November 24, 2021

Subject: North Shoreview Elementary School HVAC Replacement
San Mateo - Foster City School District
Aedis Project No. 2021005.05
DSA Application #01-119554

ADDENDUM NO. 1

AD-1
A2.01

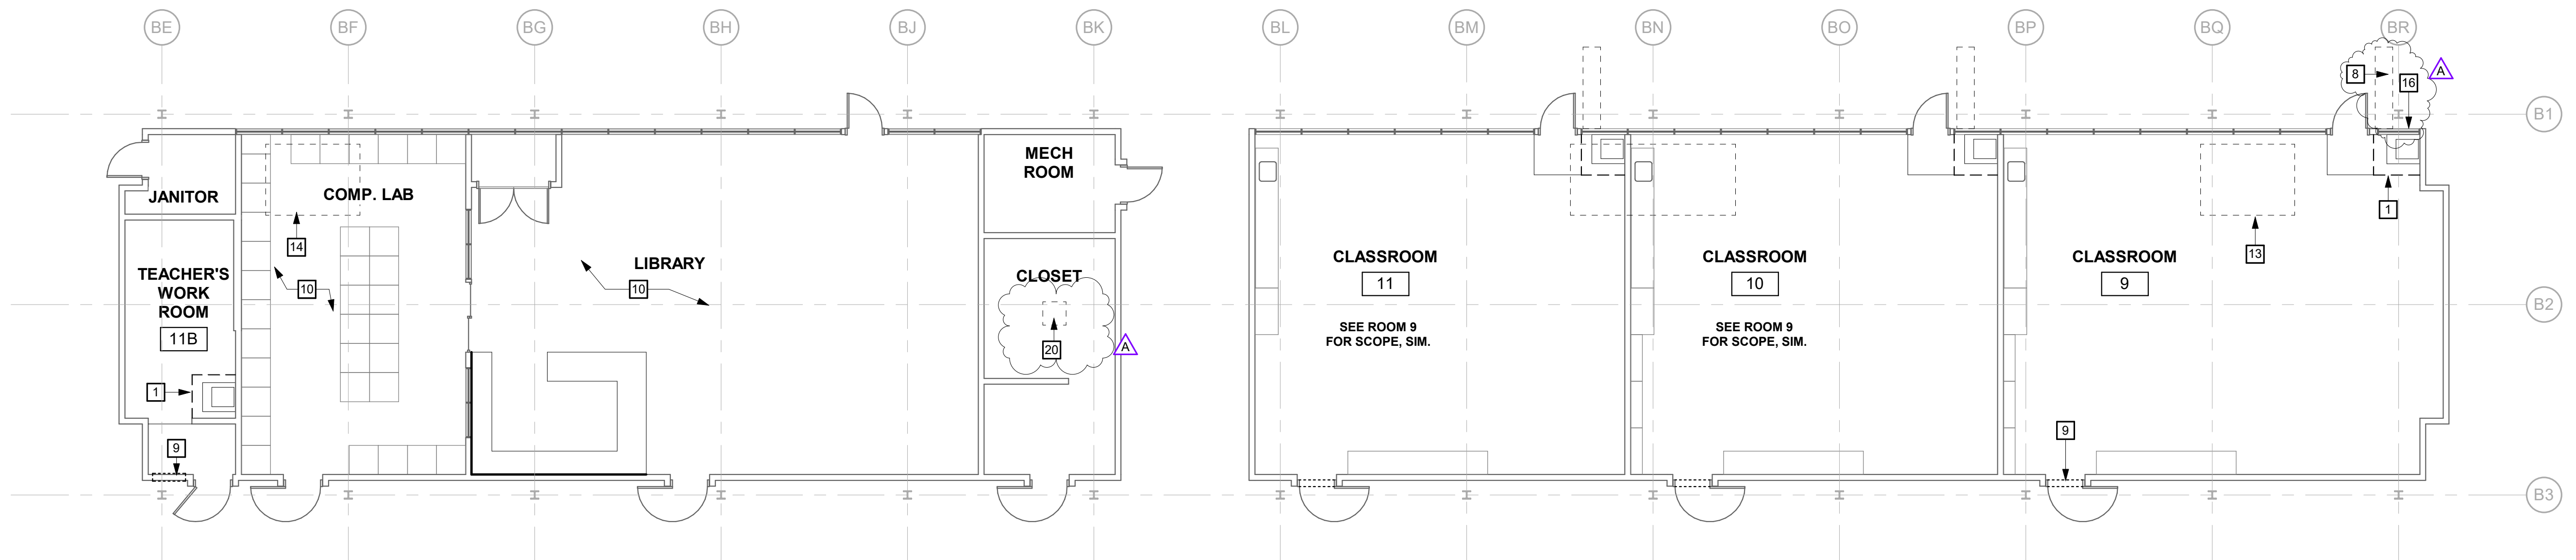
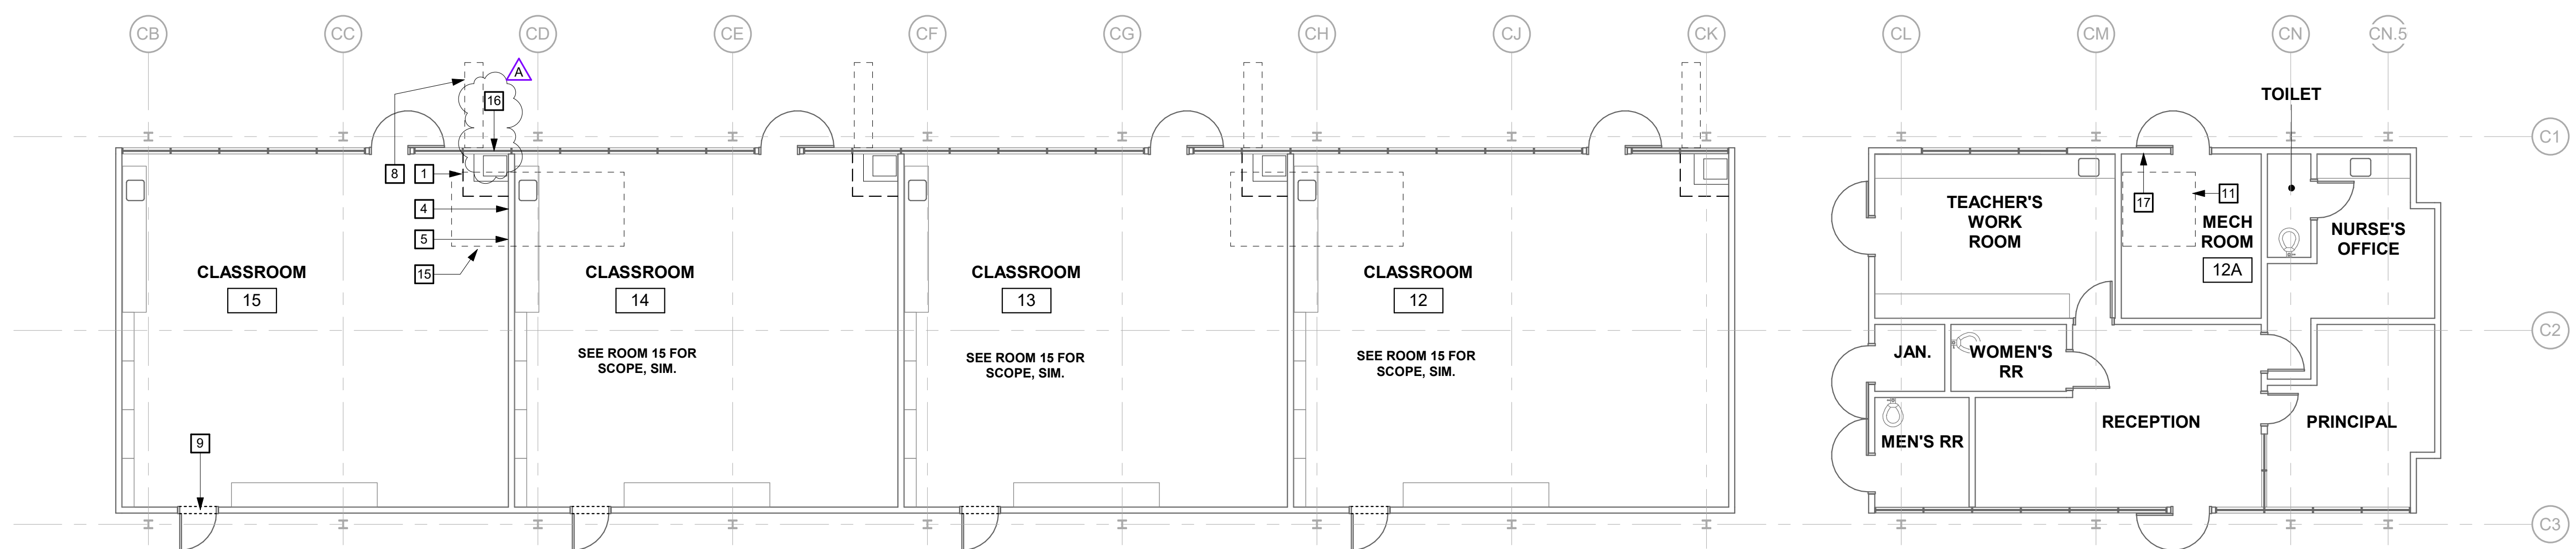
- Add: General Sheet Note #I per AD1-A2.01
- Revise: Demolition Floor Plan Keynotes #1 & #16 per AD1-A2.01
- Add: Keynote #8 to Demolition Floor Plans 1/A2.01 and 2/A2.01 per AD1-A2.01
- Add: Keynote #16 to Demolition Floor Plans 1/A2.01, 2/A2.01, and 3/A2.01 per AD1-A2.01
- Add: Partial ceiling demolition keynote #20 to Demolition Floor Plans 1/A2.01 and 2/A2.01 per AD1-A2.01

3 TYP. REFLECTED CEILING PLAN- C.P. OR GYP. BD.

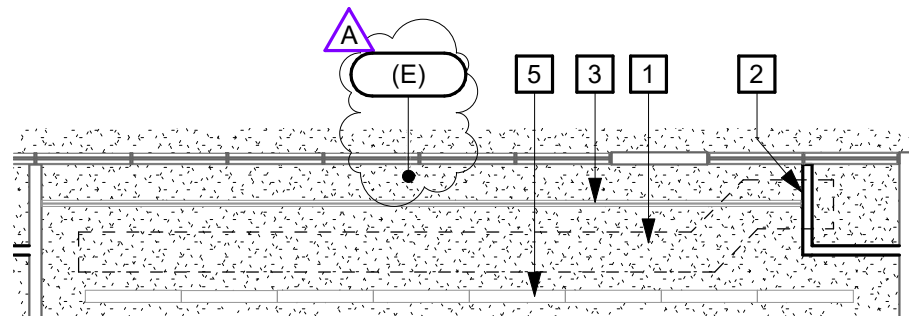
- Revise: View 3/A4.01 typical RCP at cement plaster or gypsum board per AD1-A5.01

9 ASPHALT/CONCRETE JOINT

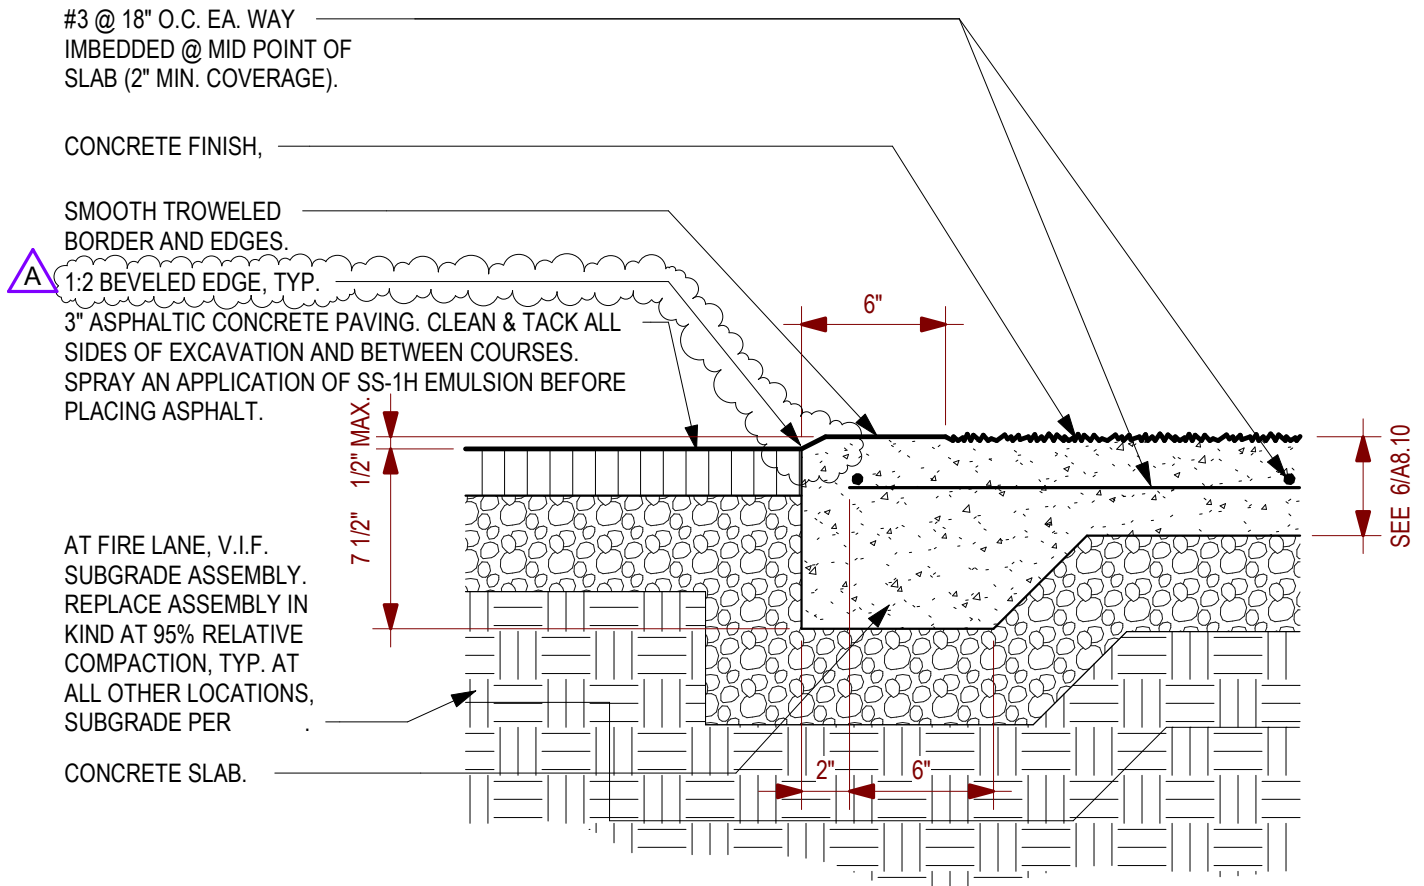
Revise: Detail 9 per AD1-A8.10

1 WALL TYPE 1 - MECHANICAL ENCLOSURE
SCALE: 1 1/2" = 1'-0"

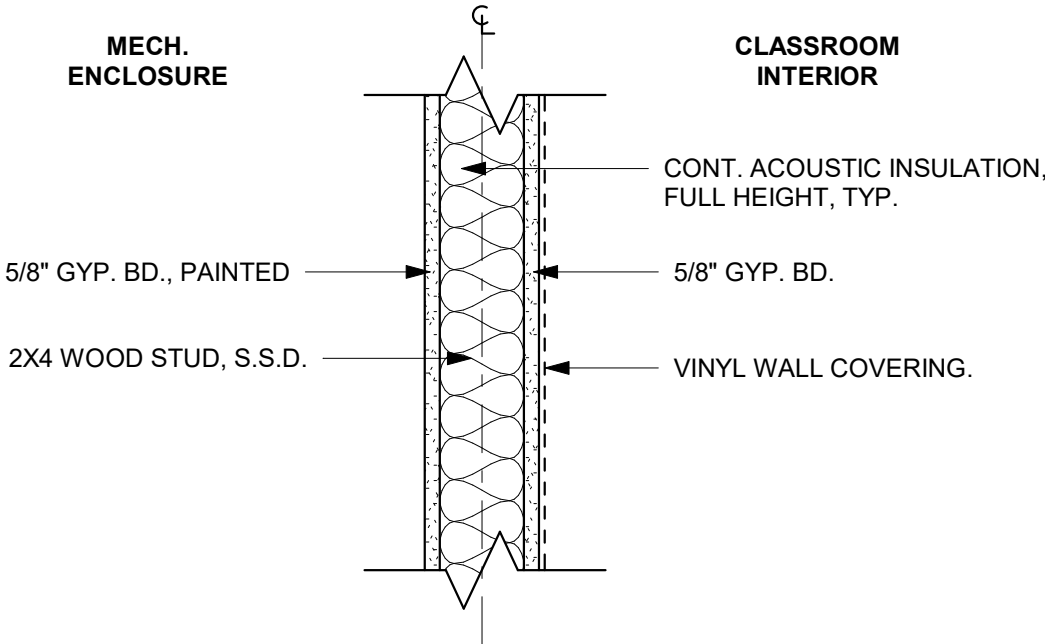
Revise: Detail 1 per AD1-A9.10A
Add: Detail 19 per AD1-A9.10A
Revise: Detail 6 per AD1-A9.10B

10 GATE POST AND FOUNDATION DETAIL

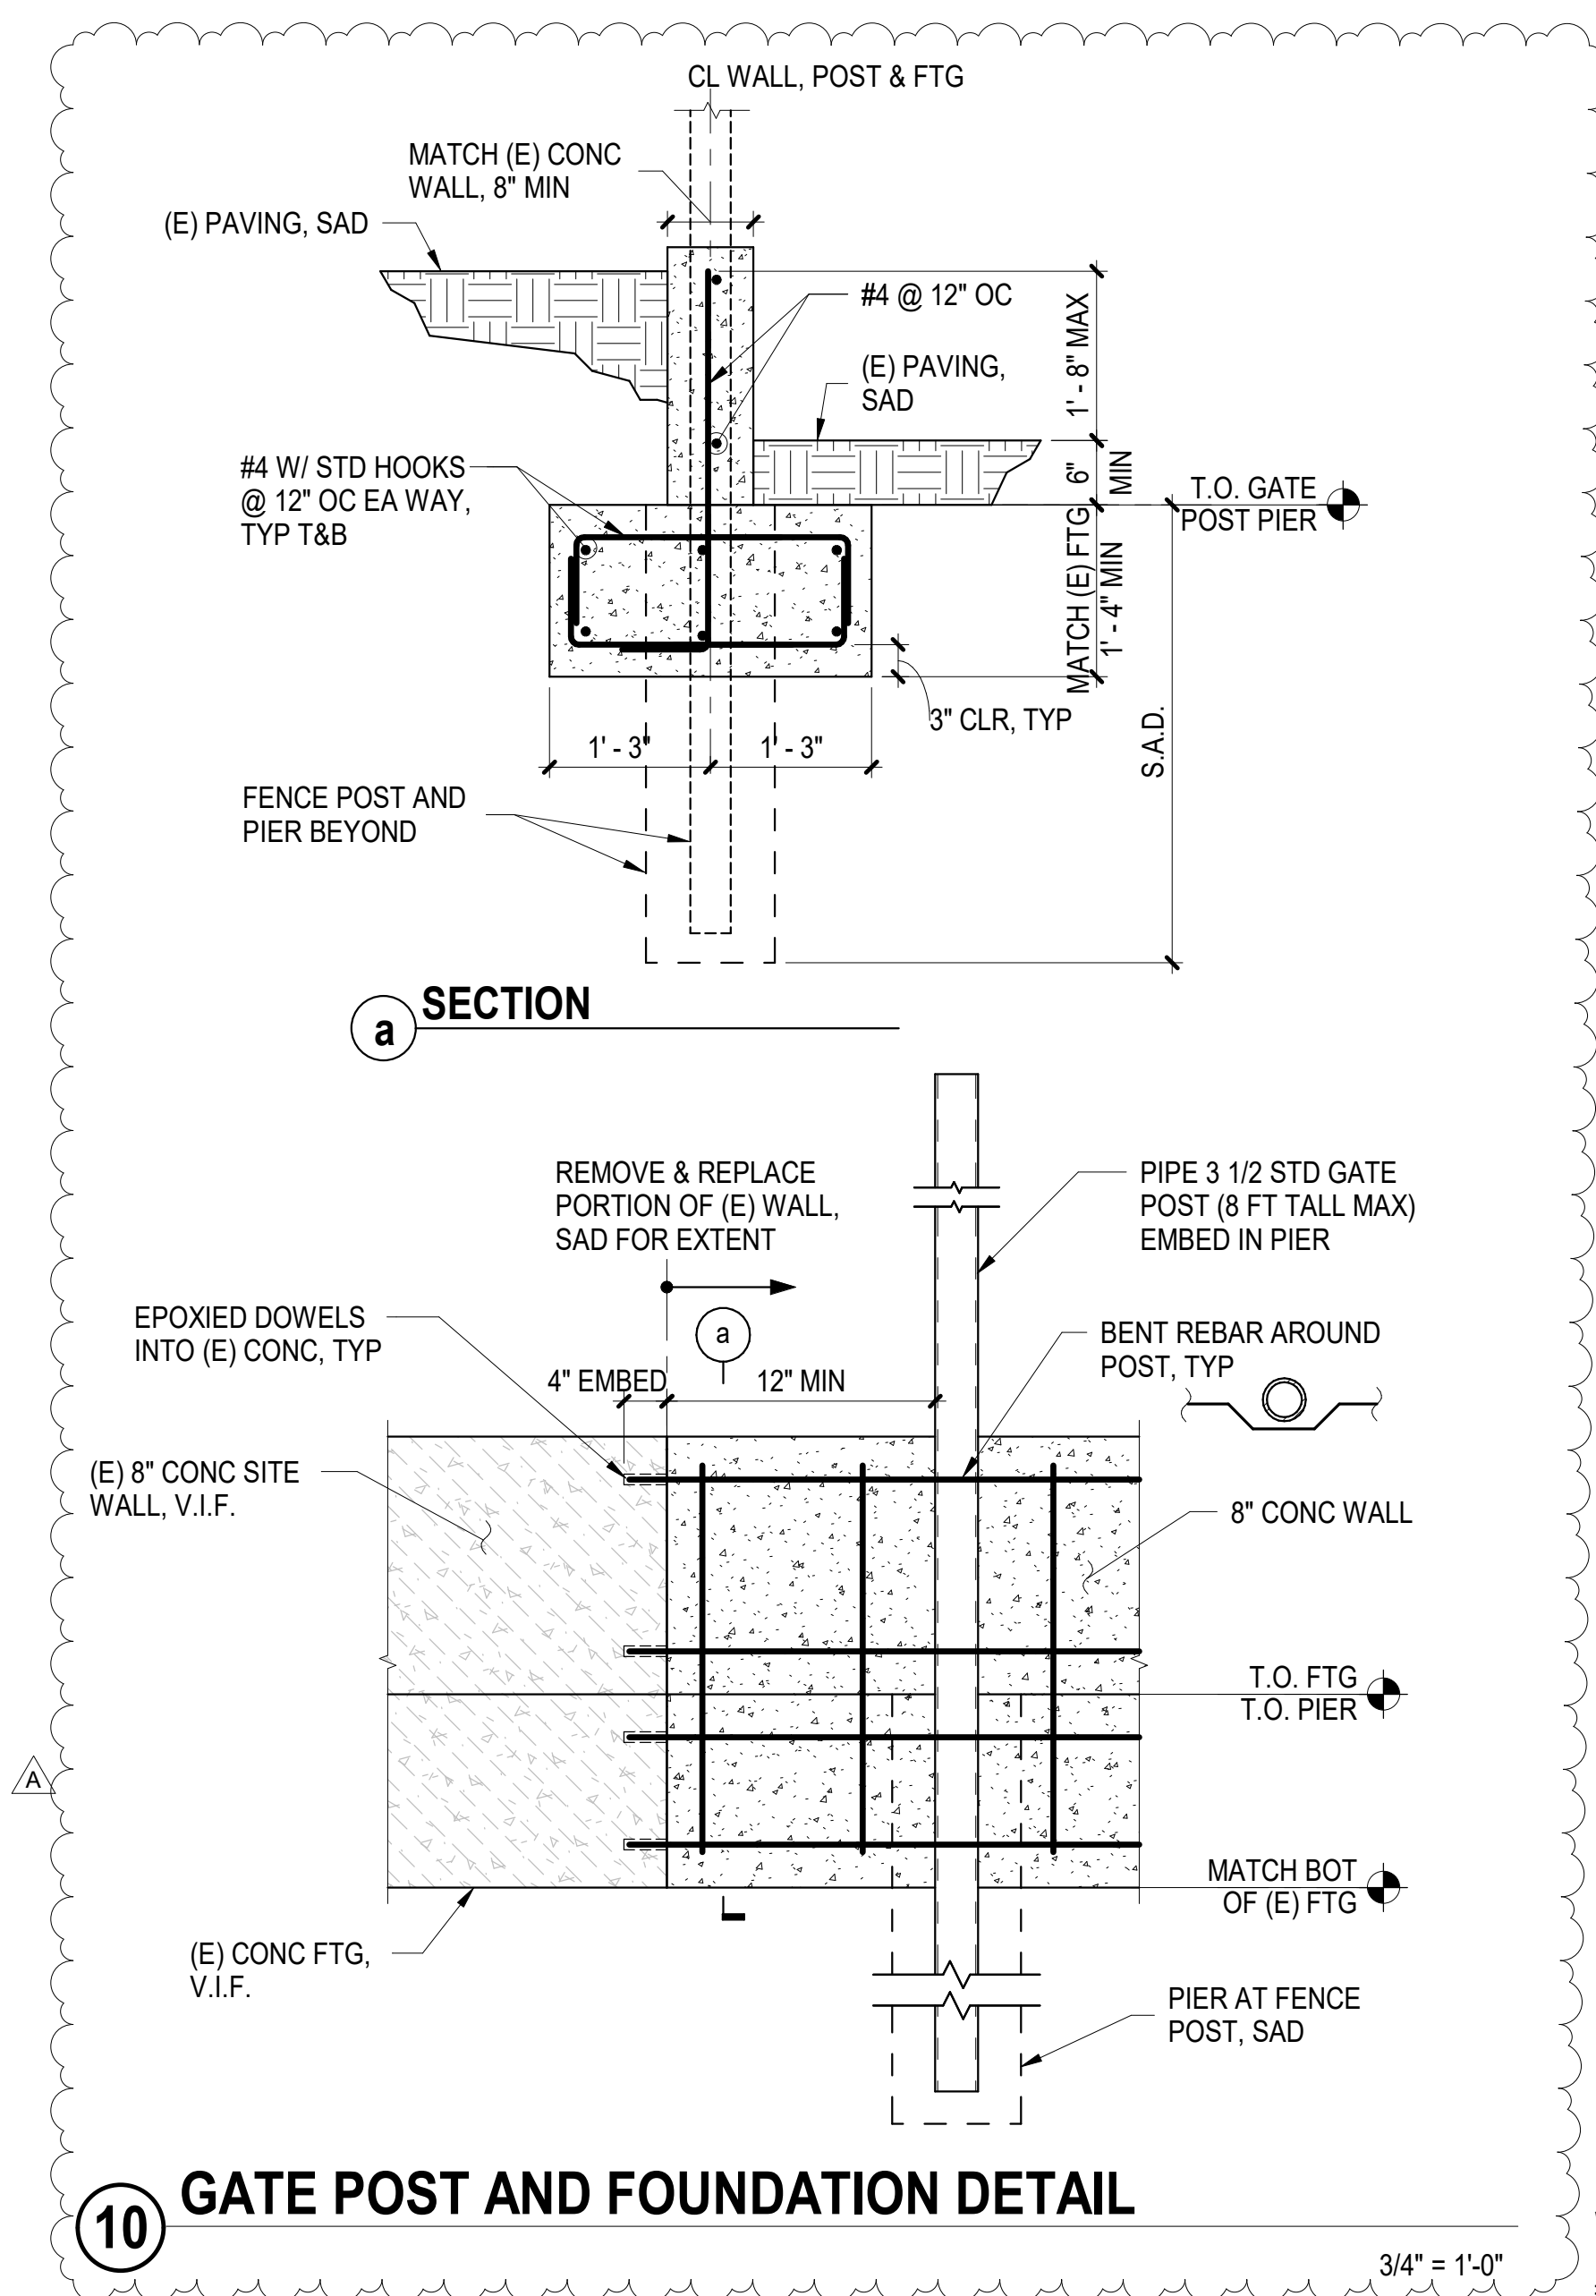
Add: Detail 10 for fence gate post foundation per AD1-S5.02.
